**FCPS NEW MIDDLE SCHOOL – POLO CLUB**  
**KDE BG # 21-176**  
**FCPS BID # 20-21**  
**JRA Project No. 202078**  
Fayette County Public Schools  
Lexington, Kentucky

The Addendum will form a part of the Contract Documents and modifies the original Bidding Documents dated September 2021.

**FP-112D**

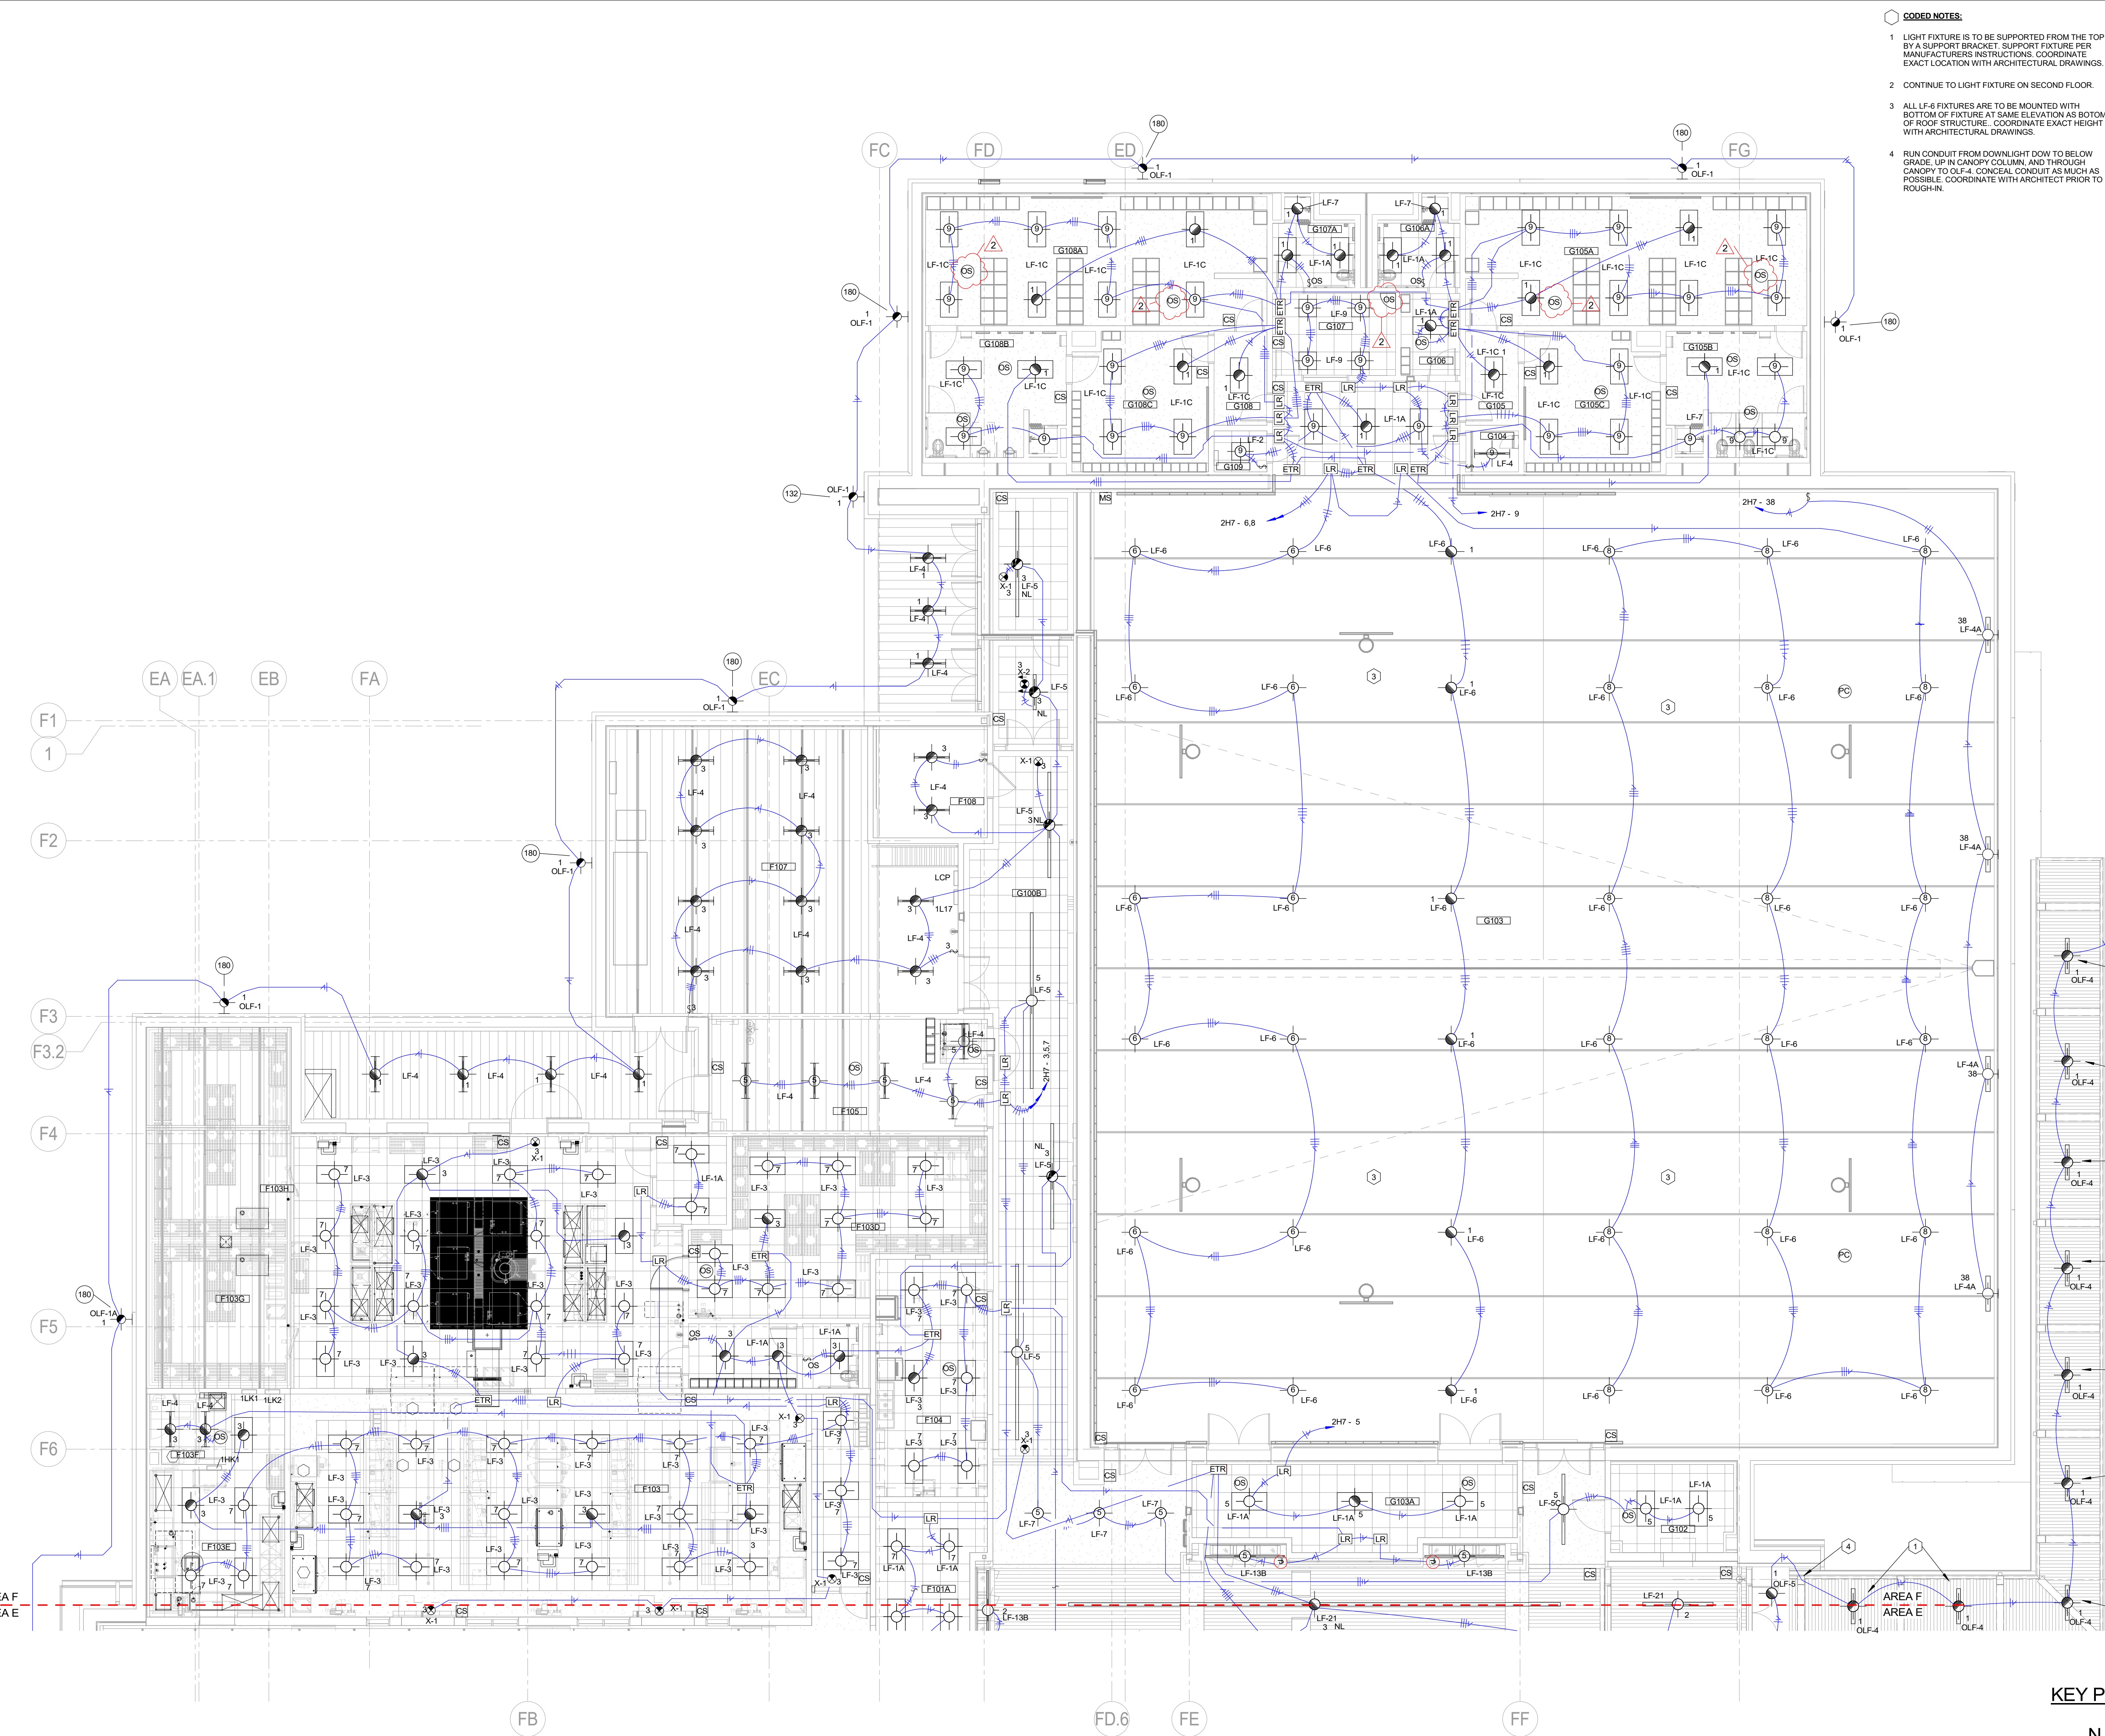
Refer to sheet FP-112D adjust Sprinkler Head locations as indicated.

**E-221F**

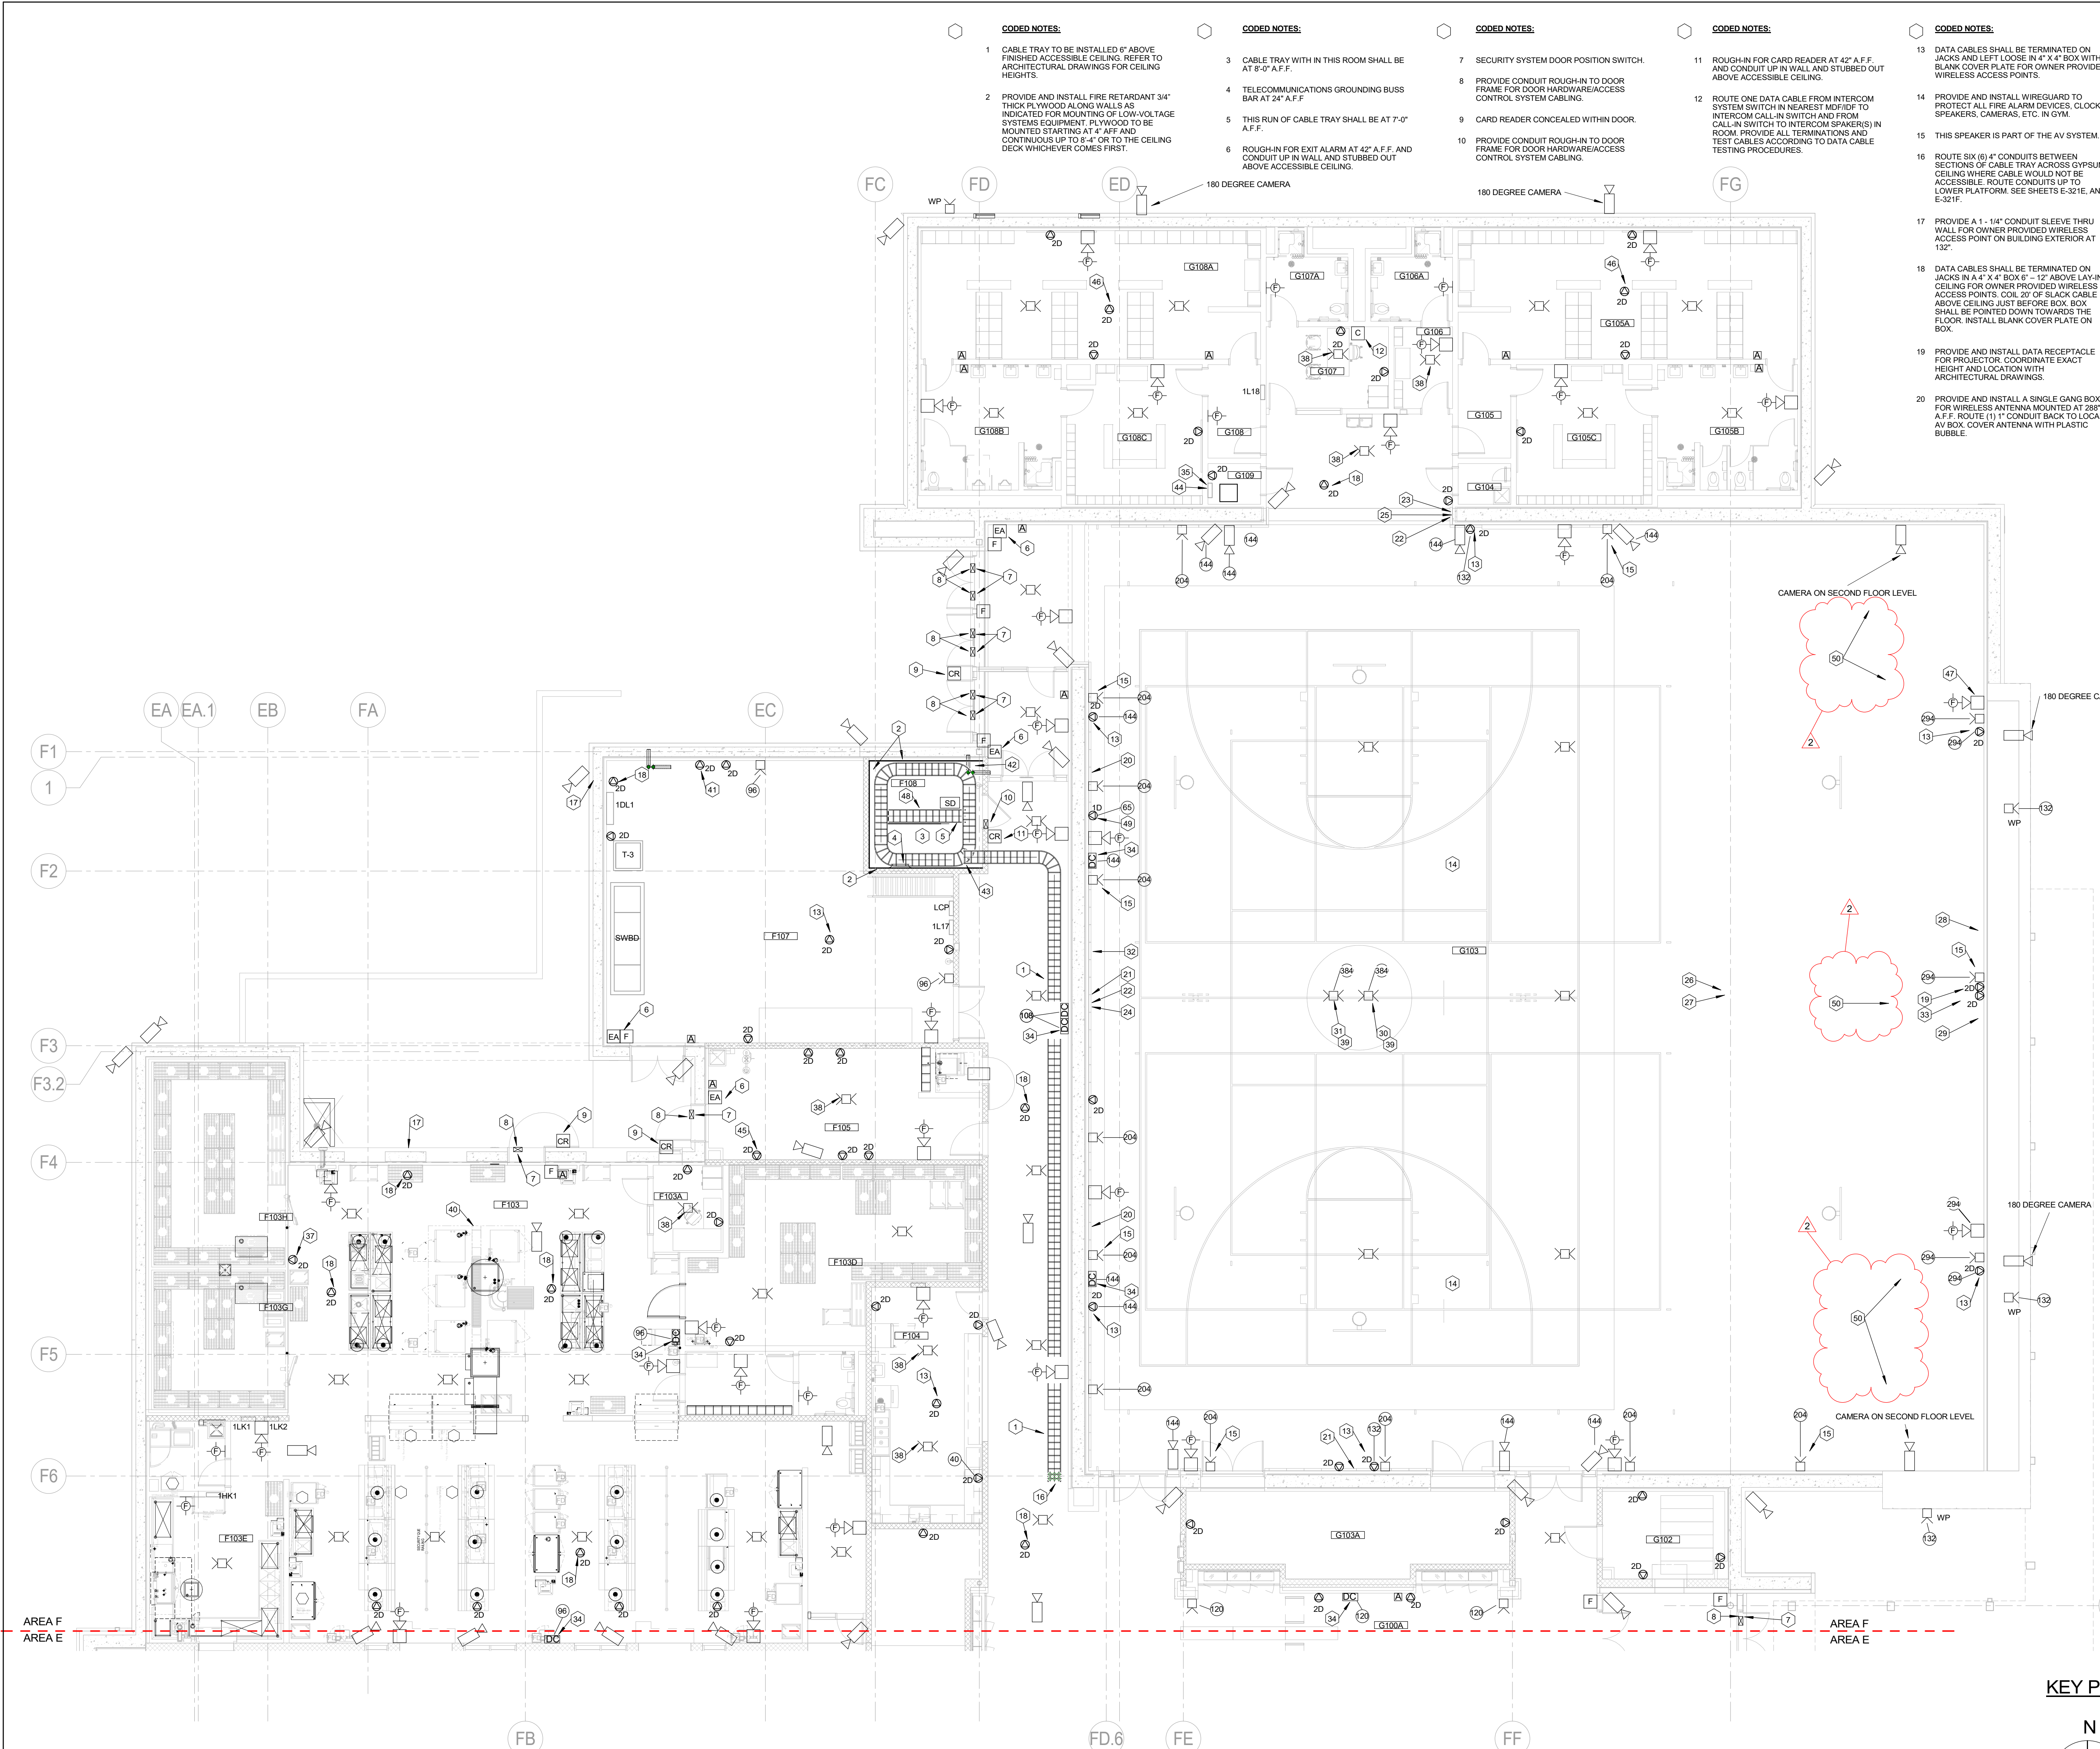
Refer to sheet E-221F revised electrical connections as shown.

**A** MICROPILE LAYOUT PLAN  
S-201 1" = 20'-0"

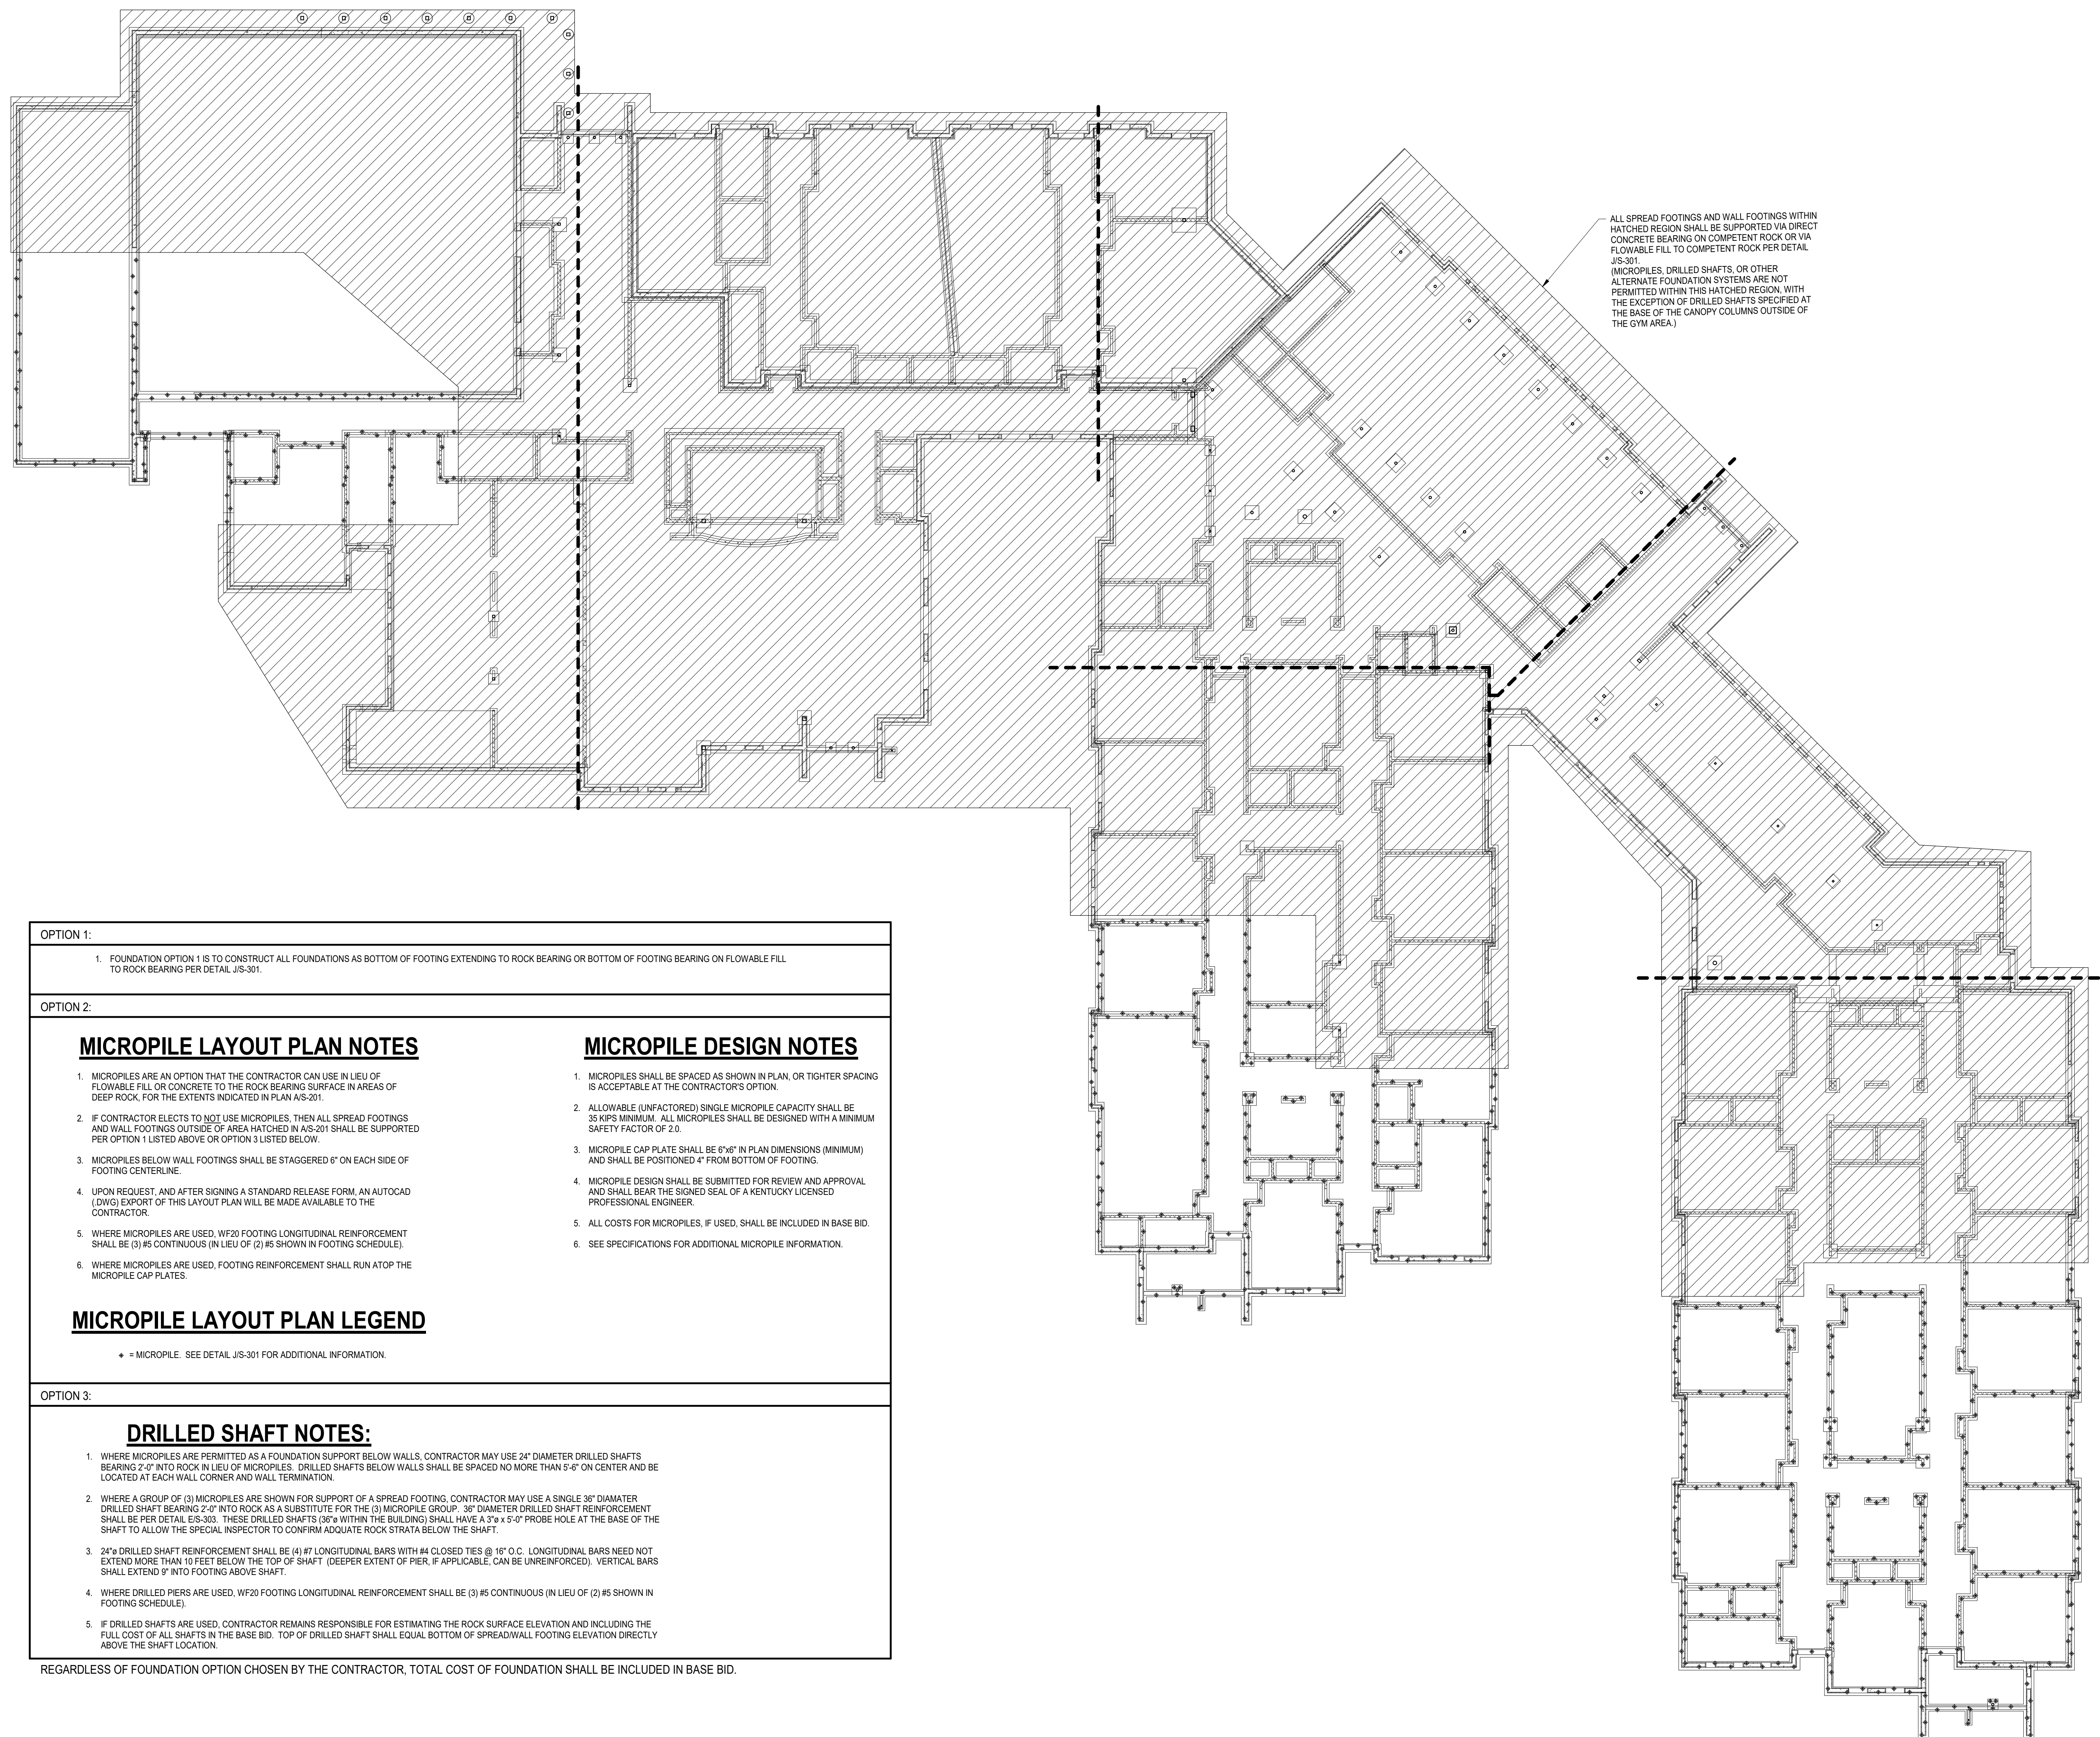
Add attached new sheet "S-201 - MICROPILE LAYOUT PLAN" to the drawing set.

2	<p>The documents do not indicate a budget, allowance, or quantity for the micro-piles. Can the engineer generate these quantities so the contractors are bidding on a level playing field?</p>	Brown+Kubican	<p>See sheet S-201, issued via Addendum 2, for relevant information that addresses this question.</p>
